We thank C. H. Twohy for his detailed review and valuable comments. The manuscript has been modified according to the suggestions proposed by the reviewer. The remainder is devoted to the specific response item-by-item on the reviewer's comments.

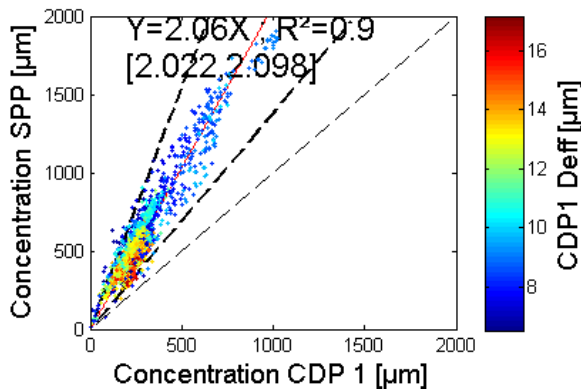
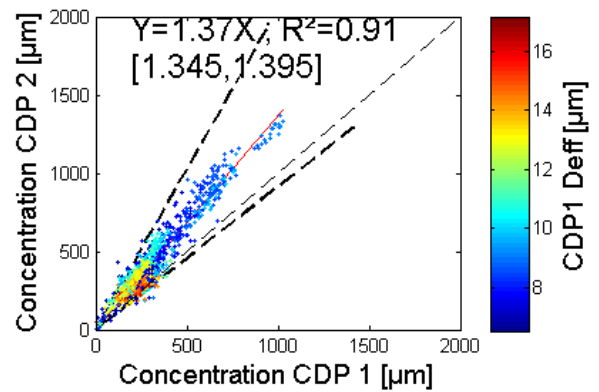
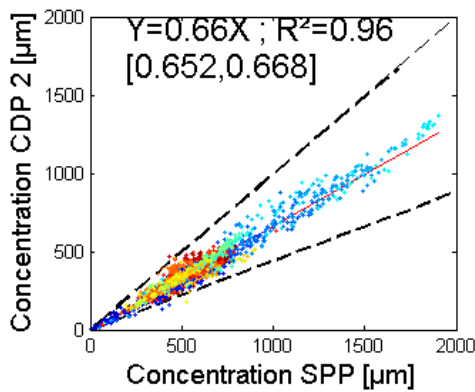
Some important results include that rapid changes in airspeed do not affect some instruments (if the speed changes are accounted for), and that other instruments are strongly dependent on alignment. Conditions affecting other instruments—for example, mean inlet speeds (p. 22) and splashing (p. 16) are likely manifested differently with droplet size. However, limited comparisons based on droplet size are made (except for the alignment and SPP/FSSP comparison studies). It would be useful if this were done for the dataset as a whole. Likewise, droplet number concentration may affect the results due to coincidence, and some stratifying by number might also yield interesting results.

RC: Lines 632-638: If the droplet speed inside the inlets is a major uncertainty, then it might be expected that the results depend on droplet size. This should be explored.

The size dependence is observed only for the FSSP and is investigate in the appendix.

Line 737: *As the FSSP is aspirated with no flow straightener in front of it, turbulent flow and distortion of the size distributions can be expected. Anisokinetic sampling and errors in the sampling volume can explained the concentration overestimation. For the other instruments, the biases were constant during the campaign and independent of the wind speed and the droplet size (not show).*

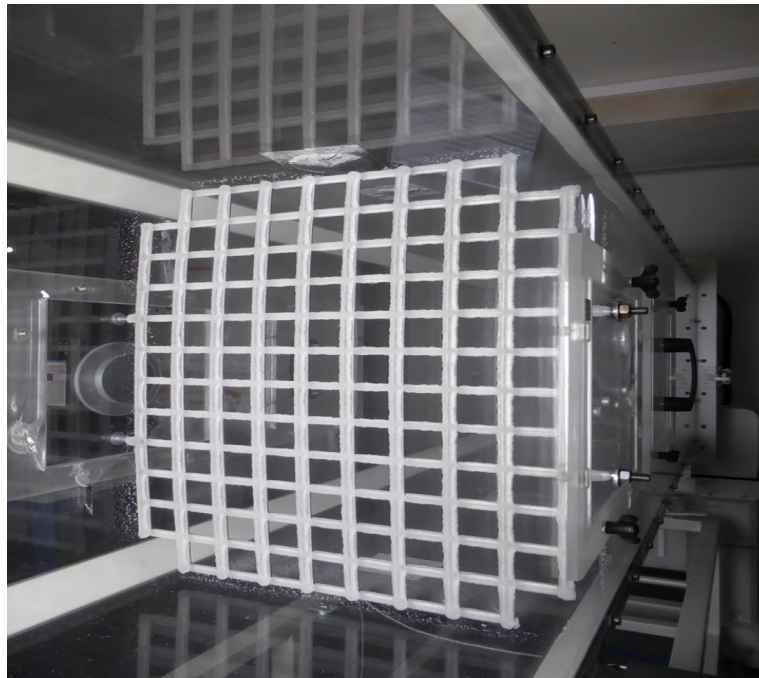
RC: Lines 547-548: I don't think this has been addressed. Why is the airflow more accurately monitored in the wind tunnel than in the ambient air? Add in Methods section.

AR: The text below has been added to Section 2.2.

Line 456: The method of an icing grid (see, e.g., Irvine et al. 2001) was used for airflow uniformity measurement. The tests were performed at the maximal airspeed available in the wind tunnel. According to the preliminary results, the variations of the thicknesses and widths of the iced bands were lower than 5 %, i.e., of the order of the uncertainty of the method (see picture below, P. Personne and C. Verhaege personal communication). Thus, we can reject the hypothesis of the airflow heterogeneity as the cause of the differences between data.
